## Changes to the packaging of MELSEC-F series programmable controller peripheral devices

MELSEC-F series

FAM-A-0066-A

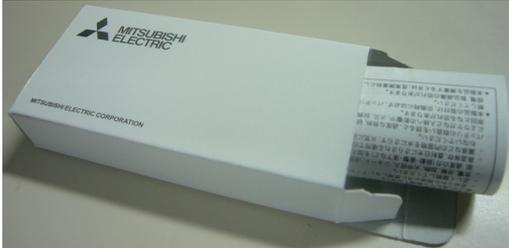
The product packaging and how the product accessories are packaged will be changed to improve quality (to prevent deformation of PET packaging at high temperatures).
